# RENESAS TECHNICAL UPDATE

Product Category	System LSI		Document No.	TN-USB-A0004A/E	Rev.	1.00
Title	μPD720202K8-701-BAA-A External Serial ROM Connection circuit update		Information Category	Technical Notification		
Applicable Product	μPD720202K8-701-BAA-A	Lot No.	Reference Document	μPD720201/μPD720202 Data Sheet (R19DS0047EJ0600) μPD720201/μPD720202 User's Manual: Hardware (R19UH0078EJ0600)

This documentation describes the notification to revise the recommended circuit with an external serial ROM for only μPD720202K8-701-BAA-A in μPD720201/μPD720202 User's Manual: Hardware (R19UH0078EJ0600).

## 1. New recommended circuit

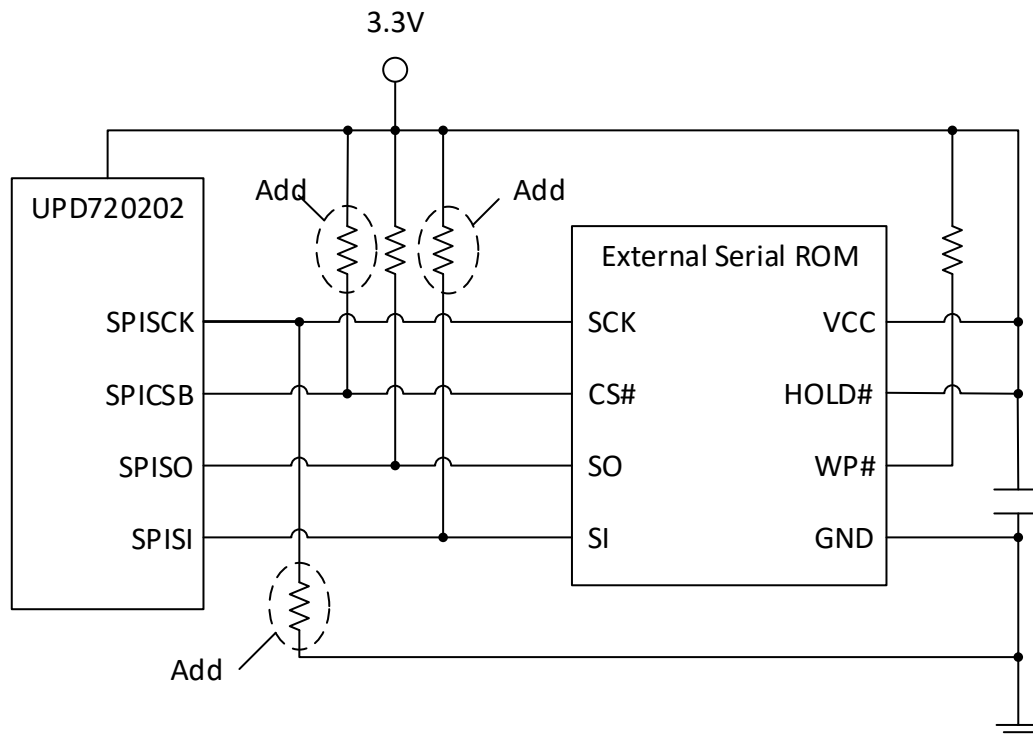
The new recommended circuit is the following figure so that μPD720202K8-701-BAA-A gets the power consumption which is in μPD720201/μPD720202 Data Sheet (Doc#. R19DS0047EJ0600).

- A. Adds the pulldown resistor on SPISCK
- B. Adds the pullup resistor on SPICSB
- C. Adds the pullup resistor on SPISI

**Figure 5-7. External Serial ROM Connection**

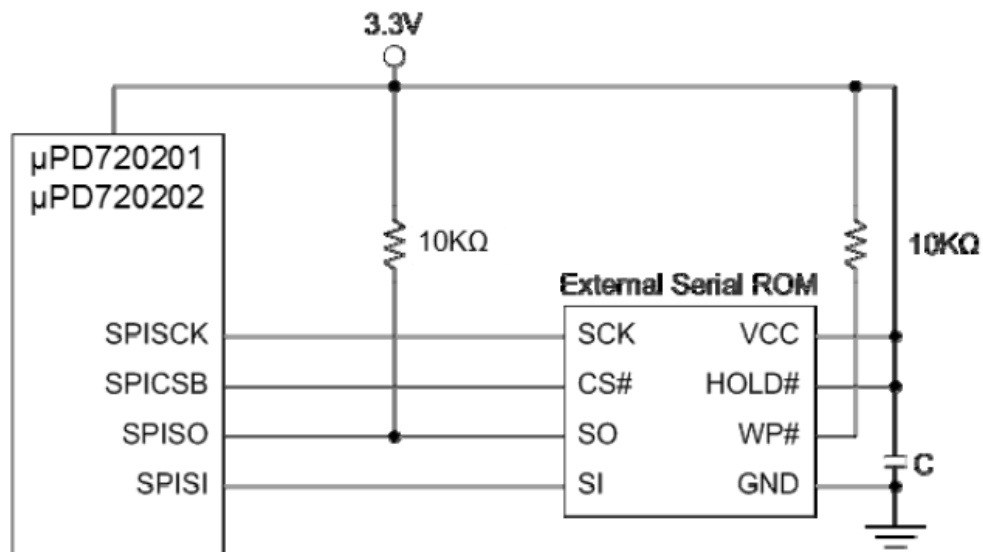
μPD720202K8-701-BAA-A does not have the power consumption with using the recommended circuit which is described in Figure 5-7 of μPD720201/μPD720202 User's Manual: Hardware (R19UH0078EJ0600) as below when

μPD720202K8-701-BAA-A enters into D3-cold state.

**Figure 5-7. External Serial ROM Connection (b)**

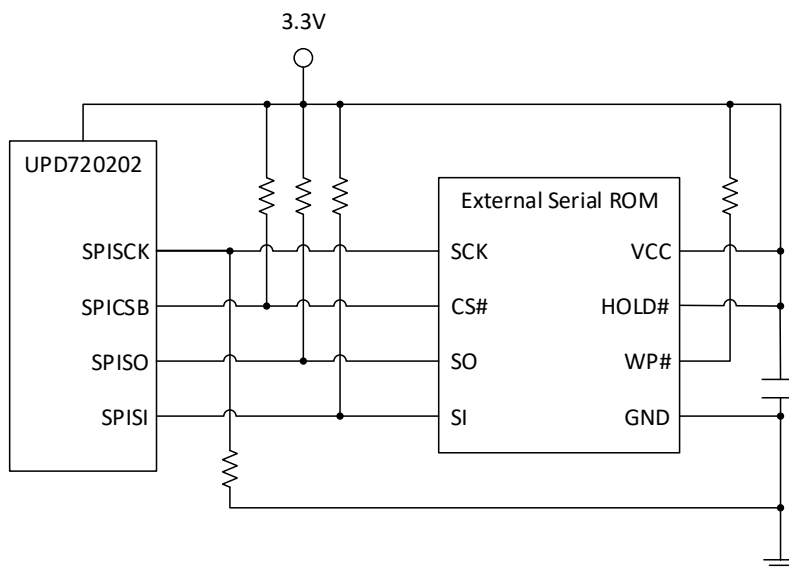
Will update  $\mu$ PD720201/ $\mu$ PD720202 User's Manual: Hardware (R19UH0078EJ0600) as the following

**Note:** The 3.3 V that pulls SO must be the same as the 3.3 V supplied to the  $\mu$ PD720202
